TRANS/WP.15/2000/15/Rev. 1
20 April 2001

Transmitted by the Government of Italy

**CHAPTER 9.1 – SCOPE, DEFINITIONS AND CLASSIFICATIONS AND
REQUIREMENTS FOR THE APPROVAL OF THE ADR
VEHICLES**

**CHAPTER 9.2 – REQUIREMENTS CONCERNING THE CONSTRUCTION
OF VEHICLES**

APPENDIX 1 – Explanatory layout of the procedures for ADR vehicles

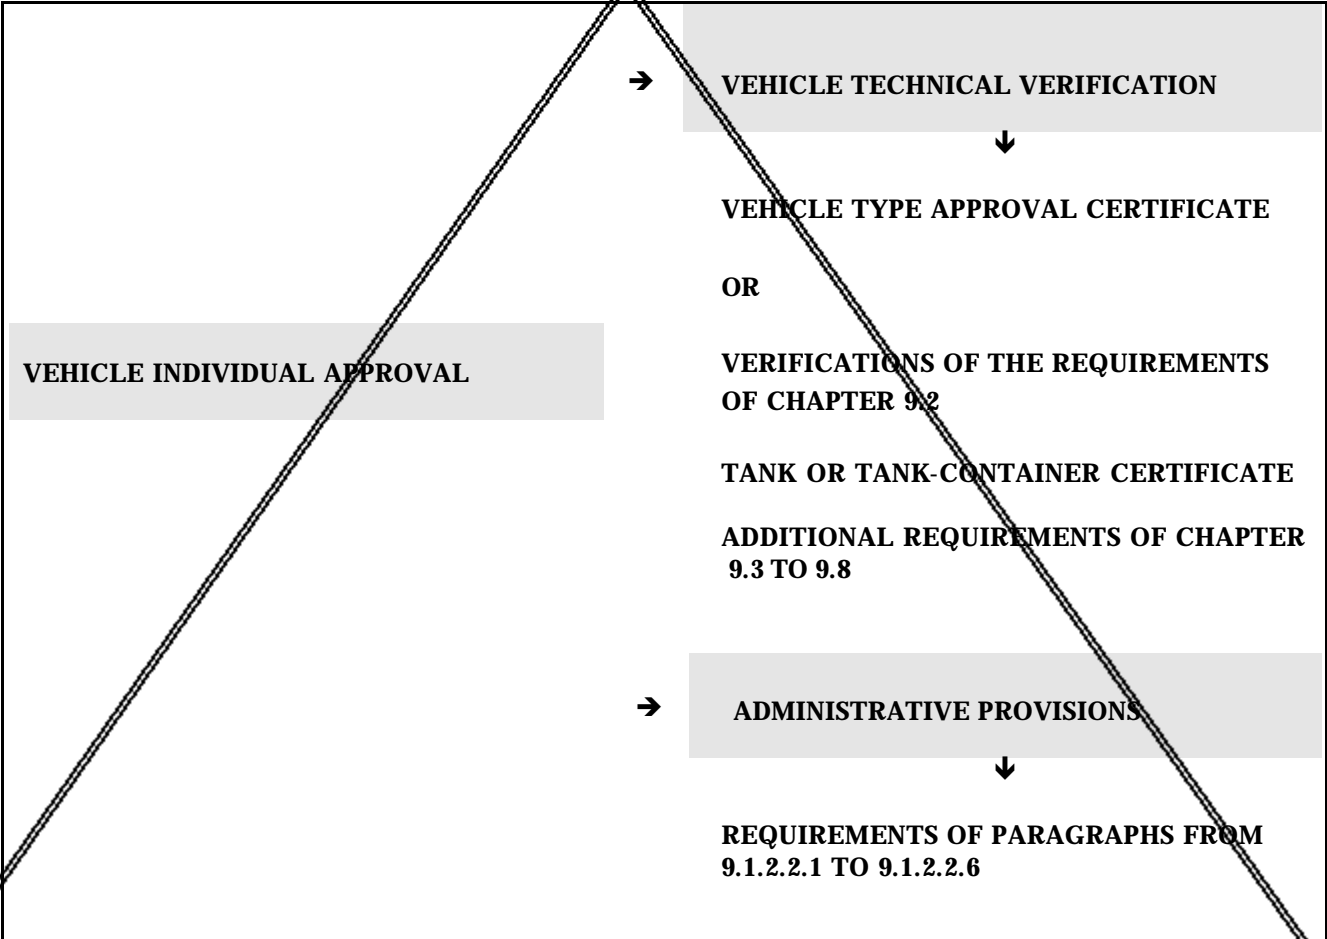
- 9.1. New title
- 9.1.1 New title
- 9.1.1.1 Scope – the added sentence underlines that the prescriptions are valid for the construction and the Type approval of the vehicle and for its Individual approval.
- 9.1.1.2 “Base vehicle” definition deleted and replaced with “Vehicle” and the added definitions of complete, incomplete and completed vehicle.

APPENDIX 1 New added

The explanatory layout of the mentioned procedures in the paragraphs 9.1.2.1 and 9.1.2.2 for ADR vehicles is given in APPENDIX 1.
